**Flood Control Project Maintenance  
Levee Inspections**  
**LMA District Cover Sheet**  
**Spring 2019 Levee Inspection Results**

**Reclamation District No. 0501 Ryer Island**

**Levee Inspection Report By Mile - Spring 2019**

Photo 1 of 3 : UCIP\_SP\_2019\_44720\_73904.jpg

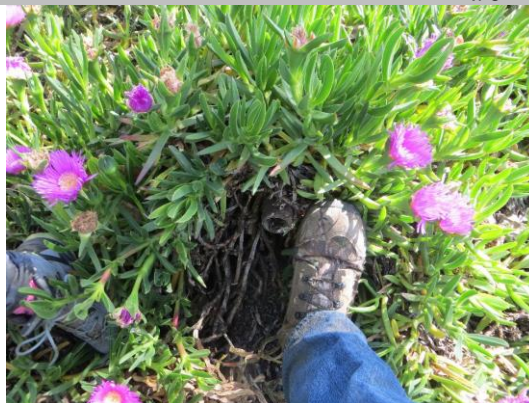
LM Start	4.57	Rating **	M	Issue No.	159
LM End	4.57	Issue Type +	En	Location *	
Category	Supplemental			GPS Latitude/Longitude	
				Start	End
Item	DWR UCIP Field Study			38.194438 °	38.194438 °
				-121.623063 °	-121.623063 °
DWR ID	21103				
Comment Code					
Inspector Comment					
FS_ID:44720 DS_ID:21103 EP_NO: N/A Repair Type: Non-Urgent Crossing Status: Indicator Found UCIP Comments: Need to verify type of abandonment and if needed abandon it properly. FIELD_STRUCT_DESC: *ABANDONED* 12-inch pipe of an unknown material or purpose through the levee, 3 feet below the crown. 1.5-inch electrical conduit is visible on the landside (LS) slope, 3 feet below the crown, good indicator for the pipe crossing. [Additional Reference(s): USACE Sacramento O&M Manual 105, April 1959, (HLM 4.9)]. FS Date: 4/21/2015

Pipe visible on LS slope. Succulants mound up over pipe.

Photo 1 of 2 : SP\_2019\_RD0501\_169\_21\_20190314\_00073.jpg

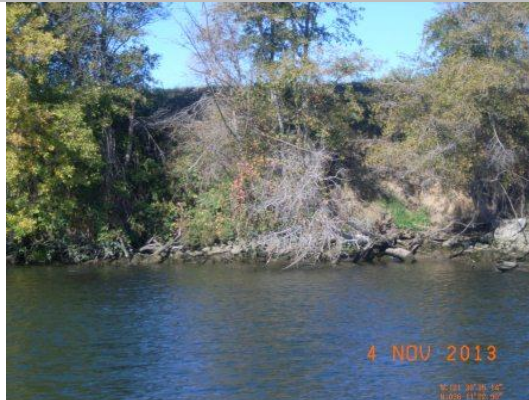
2017 Site ID: STM 15.7 R  
 Status: Eroding  
 2017 Field Notes: No observed change.  
 Site History: 2008 - Overstepped levee section with multiple small pockets of erosion 10 - 20 ft wide. 2013 - Site has fresh erosion and taller vertical sections.  
 Spring 2019 Notes: Tree fallen next to worst of erosion spot during February highwater events

View looking downstream at tree that recently fell next to worst of the erosion spots. Tree fell during the February 2019 highwater events (Spring 2019).

Photo 2 of 3 : UCIP\_SP\_2019\_44865\_58972.jpg

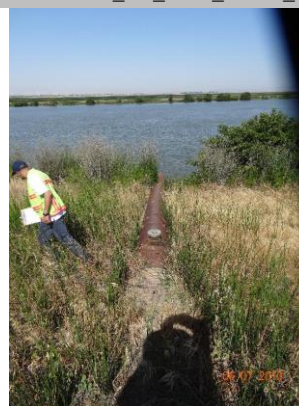
Comment Code						
Inspector Comment						
FS_ID:44865 DS_ID:21038 EP_NO: 2817 Repair Type: Non-Urgent Crossing Status: Found UCIP Comments: Dense vegetation limits the inspector's visibility to identify signs of pipe failure (leaks) through the slope. Recommend removing vegetation along pipe alignment to conduct proper inspection of structure and appurtenances. Scour hole located on waterward side. FIELD_STRUCT_DESC: 20-inch steel drainage discharge pipe sleeved through a 24-inch steel pipe through the levee, 9 feet below the crown. Flap gate on the waterside (WS) end. Cutoff wall around the pipe at each shoulder. Pipe exposed along both slopes. Rock revetment on the WS slope. Berm on the WS is over 20 feet. (Plans to install a drainage pipe through the levee authorized under Permit No. 2817, 1958 - Reclamation District No. 501 [RD0501]). [Additional Reference(s): DWR Levee Log, 2005]. FS Date: 6/7/2013

View of waterward side--pipe section exposed and siphon breaker. Over 20 feet berm on waterward side.

Photo 1 of 2 : UCIP\_SP\_2019\_32541\_59008.jpg

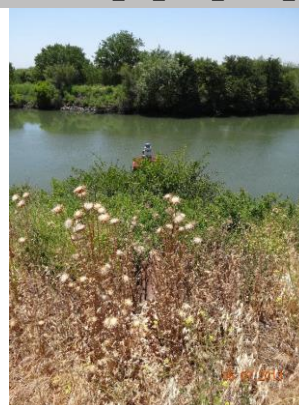
Comment Code					
Inspector Comment					
FS_ID:32541 DS_ID:21071 EP_NO: N/A Repair Type: Non-Urgent Crossing Status: Found UCIP Comments: --Contact owner--Dense vegetation limits the inspector's visibility to identify signs of pipe failure (leaks) along the waterward and landward slopes. Recommend removing vegetation along pipe alignment to conduct proper inspection of structure and appurtances. Walkway and siphon breaker not found. FIELD_STRUCT_DESC: 12-inch reinforced concrete irrigation discharge pipe through the levee, 2.5 feet below the crown. Cutoff wall around the pipe at the center of the levee. Siphon breaker at the apex of the pipe on the shoulder. Pump on a pile structure in the stream. Walkway access to pump. [Additional Reference(s): DWR Levee Log, 2005. USACE Sacramento O&M Manual 105, April 1959, (HLM 5.1)]. FS Date: 6/7/2013

View of waterward side. Pump located on pile structure in stream.

Photo 2 of 3 : UCIP\_SP\_2019\_32551\_59072.jpg

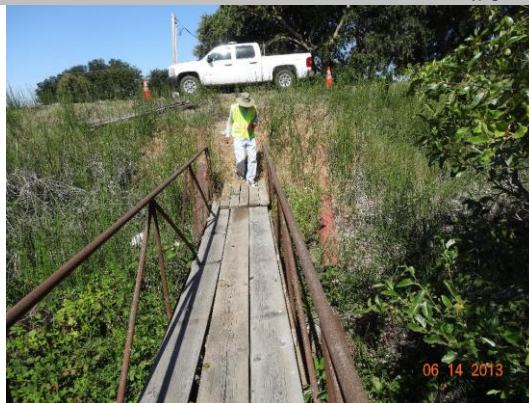
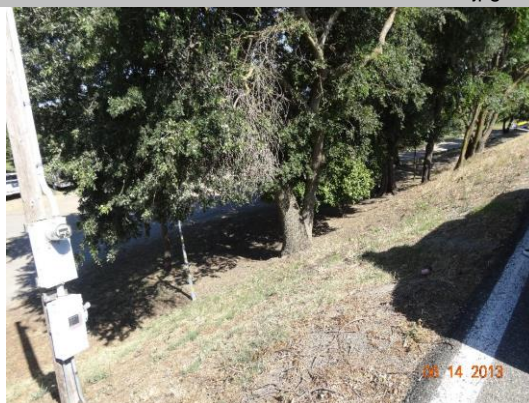
Comment Code						
Inspector Comment						
FS_ID:32551 DS_ID:21074 EP_NO: N/A Repair Type: Non-Urgent Crossing Status: Found UCIP Comments: Unable to determine status of crossing. Pipe visible on waterward side--could be the pipe that was supposed to be removed under permit number 13983 (1985). Also present is a 1.5 inch conduit along the 8 inch pipe. Need to coordinate with owner. FIELD_STRUCT_DESC: 8-inch steel irrigation discharge pipe through the levee, 6.4 feet below the crown. Pump on a pile structure in the stream. Service pole on the landside (LS) slope. (8-inch pipe should have been removed and replaced with a 12-inch pipe authorized under Permit No. 13983, 1984 - Mrs. John Thomas). [Additional Reference(s): DWR Levee Log, 2005. USACE Sacramento O&M Manual 105, April 1959, (HLM 1.3)]. FS Date: 6/13/2013

Abandoned pipe to the right of walkway.

Photo 3 of 3 : UCIP\_SP\_2019\_32552\_59075.jpg

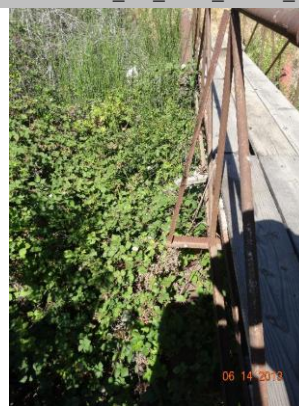
Comment Code						
Inspector Comment						
FS_ID:32552 DS_ID:21095 EP_NO: 13983 Repair Type: Non-Urgent Crossing Status: Found UCIP Comments: Abandoned pipe was to be removed during the installation of new 12-inch pipe crossing. Need to contact pipe owner. Unable to confirm crossing--need additional records for crossing. FIELD_STRUCT_DESC: 12-inch coated steel irrigation discharge pipe through the levee, 5 feet below the crown. Cutoff wall around the pipe at the center of the levee. Siphon breaker at the apex of the pipe on the landside (LS) shoulder. Pump on a pile structure in the stream. Service pole on the LS slope. Pipe connects to a 10-inch steel pipe along the LS slope at the shoulder and similarly to a preexisting 8-inch pipe on the waterside (WS). (8-inch pipe should have been removed and replaced with a 12-inch pipe authorized under Permit No. 13983, 1984 - Mrs. John Thomas). FS Date: 6/13/2013

Pipe suspended on waterward side along walkway.

Photo 1 of 1 : SP\_2019\_RD0501\_172\_20\_20190311\_00006.jpg

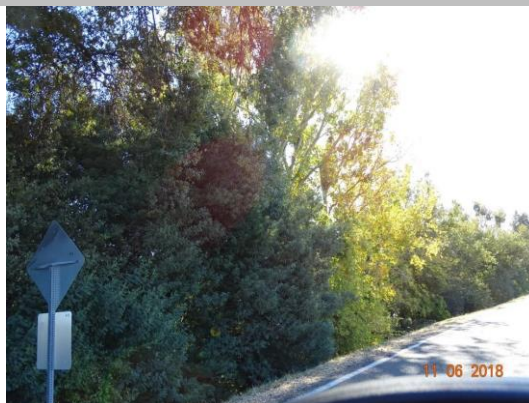
LM Start	1.49	Rating **	M	Issue No.	20
LM End	1.56	Issue Type +	Ma	Location *	WS
Category	Earthen Levee			GPS Latitude/Longitude	
				Start	End
Item	Trim / Thin Trees			38.265688 °	38.264703 °
				-121.602635 °	-121.602327 °
DWR ID	DWR_RD0501_04_f_2018_20				
Comment Code					
T2 : Thin trees to allow visibility of the ground and room to flood fight.					
Inspector Comment

View looking downstream at thick trees on the waterside slope  
(November 2018)

Photo 3 of 3 : UCIP\_SP\_2019\_32553\_59080.jpg

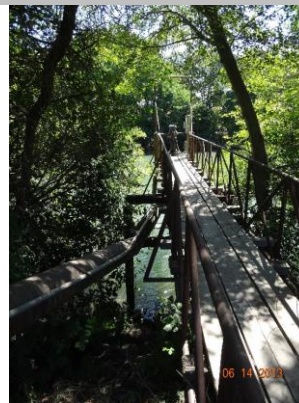
Comment Code						
Inspector Comment						
FS_ID:32553 DS_ID:21077 EP_NO: N/A Repair Type: Non-Urgent Crossing Status: Found UCIP Comments: Dense vegetation limits the inspector's visibility to identify signs of pipe failure (leaks) along the waterward and landward slope. Recommend removing vegetation along pipe alignment to conduct proper inspection of structure and appurtenances. FIELD_STRUCT_DESC: 14-inch steel irrigation discharge pipe through the levee, 8 feet below the crown. 2-inch electrical conduit of an unknown material through the levee, at an unknown depth. Siphon breaker on the landside (LS) slope. Pump on a pile structure in the stream. [Additional Reference(s): DWR Levee Log, 2005. USACE Sacramento O&M Manual 105, April 1959, (HLM 2.0)]. FS Date: 6/13/2013

Waterward side--catwalk, conduit line, pump, and support piles.
